RENESAS TECHNICAL UPDATE

Product Category	MPU/MCU		Document No.	TN-78K-A001A/E	Rev.	1.00
Title	Errata sheet 78K0/Lx3-M		Information Category	Technical Notification		
Applicable Product	78K0/Lx3-M { μ PD78F8052, μ PD78F8053, μ PD78F8054, μ PD78F8055 }		Lot No.	Reference Document	78K0/Lx3-M User's Manual: Hardware Rev.2.00 R01UH0020EJ0200 (Oct. 2010)

I'll notify following corrections on a user's manual.

Figure 17-1. Block Diagram of Extended SFR Interface

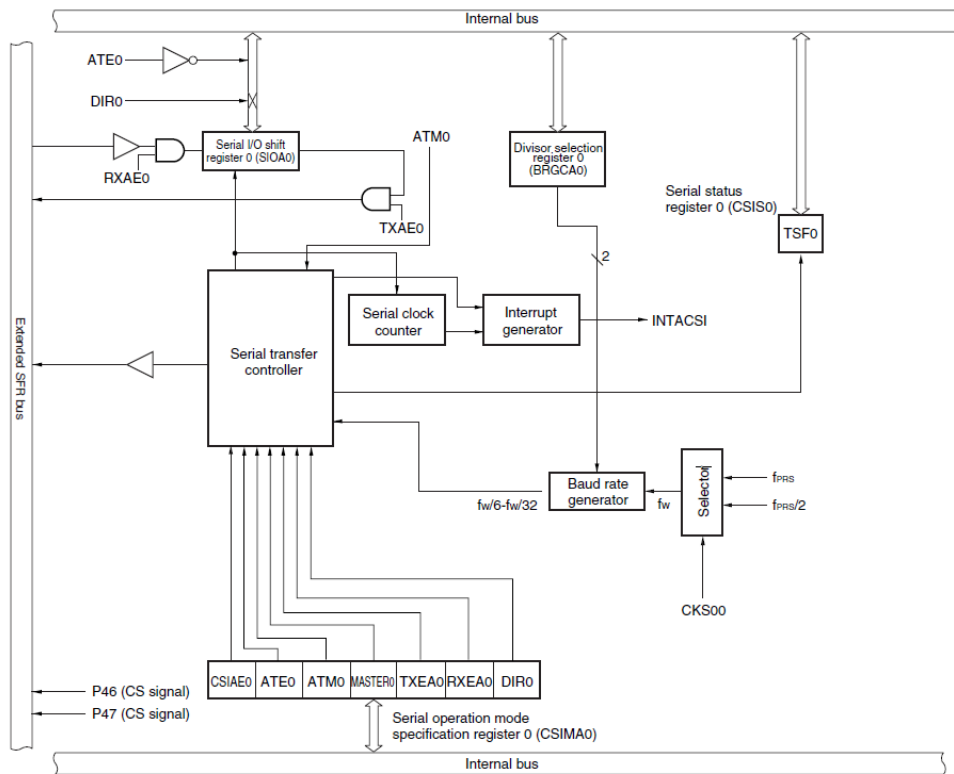
Error (1) CHAPTER 17 Figure 17-1.

Figure 17-1. Block Diagram of Extended SFR Interface

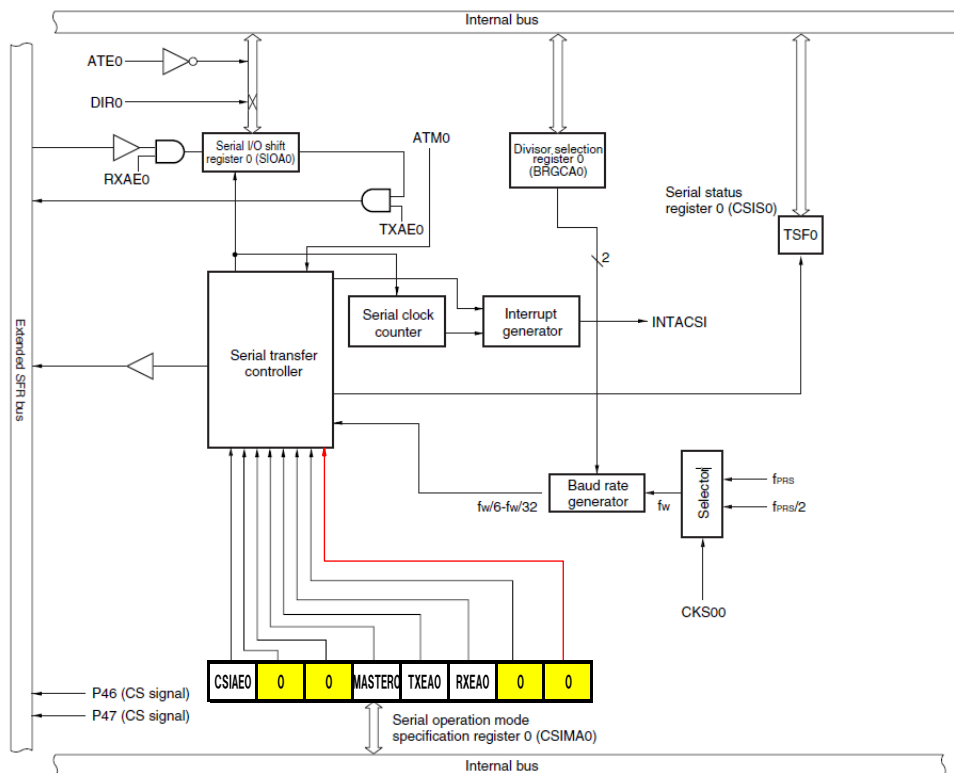
Correct(1)
